INITIAL FIRE SAFETY INSPECTION REPORT

Southend Sweater Co Ltd (Extension)

RSC ID: 26010

Date: 06-Feb-2025

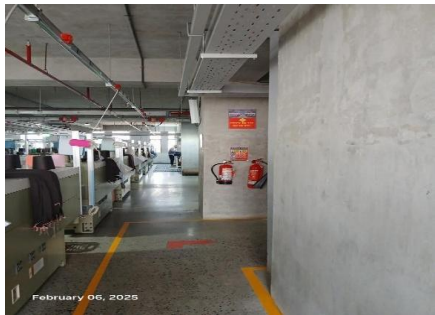
F-05	Fire Rated Construction	The required fire separation distance does not comply with the requirements of BNBC 2020 for Main Factory Building with other tenants.	The exterior walls shall have a fire resistance and opening protection as specified in BNBC 2020 Part 3 Table 3.2.2 & 3.2.3 and BNBC 2020 Part 3 Section 2.4.1.3.	Within 4 months

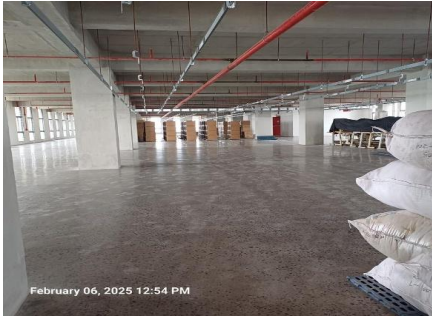
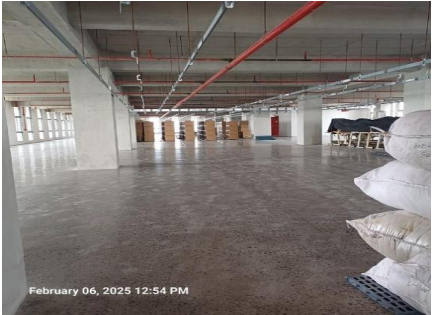
F-06	Means of Egress	The exit stair enclosures are not separated from work areas and other spaces on each floor by fire-rated construction in Main Factory Building due to- i. Unsealed penetrations are located in exit stair enclosure. ii. Fire rated doors are installed at exit stair enclosure and doors are found open with magnetic door holder, but fire alarm & detection system is found non-functional during inspection. iii. Gap below fire rated door is found more than maximum allowable limit. Smoke seal of fire rated door is found damaged in several locations.	The exit stair enclosure shall be provided with a minimum 1-hr fire resistance rating for buildings with 3 or fewer stories and a minimum of 2- hr. fire resistance rating for buildings 4 or more stories. Provide 1 hr. fire rated door and seal all penetrations and openings by 1 hr. fire rated fire rated barrier construction for building with 3 or fewer stories. Provide 1.5 hr. fire rated door and seal all penetrations and openings by 2 hr. fire rated fire rated barrier construction for building with 4 or more stories. Provide a fire-resistive rated assembly between the exterior exit stairs and the building up to 10 ft. beyond the end of the stair to achieve the required separation. The rated assembly shall be approved and/or designed by a qualified fire protection engineer. Ensure that the fire doors are self-closing and positive latching and that they are provided with fire exit (panic) hardware where serving production floors. If fire doors are required to be held open for functional reasons, provide automatic closing devices tied to the fire alarm system. The clearance under the bottom of a fire rated door shall be a maximum of 3/4 in. (19 mm). Replace/install the non-functional/missing fire door accessories and properly inspect, test & maintain fire door as per NFPA 80.	Within 3 months

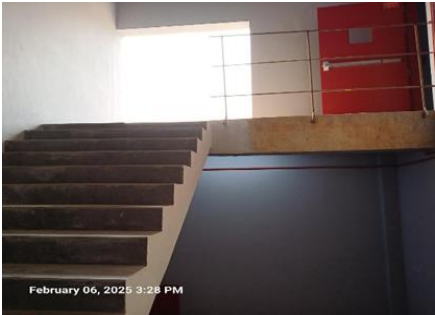
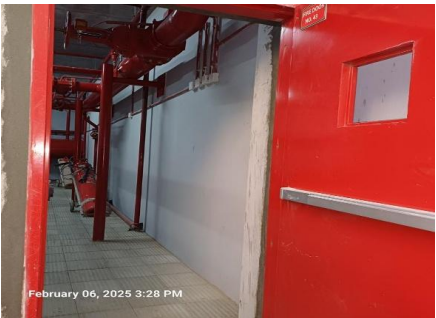
F-07	Means of Egress	Building did not have occupant load signs in 9th floor Main Factory Building and assembly and proper stair designation signs at required locations on all floors.	Provide occupant load signs and appropriate stair designation signs at required locations. Post the occupant load for every assembly and production floor in a facility in a conspicuous space near the main exit or exit access doorway for the space.	Within 1 month
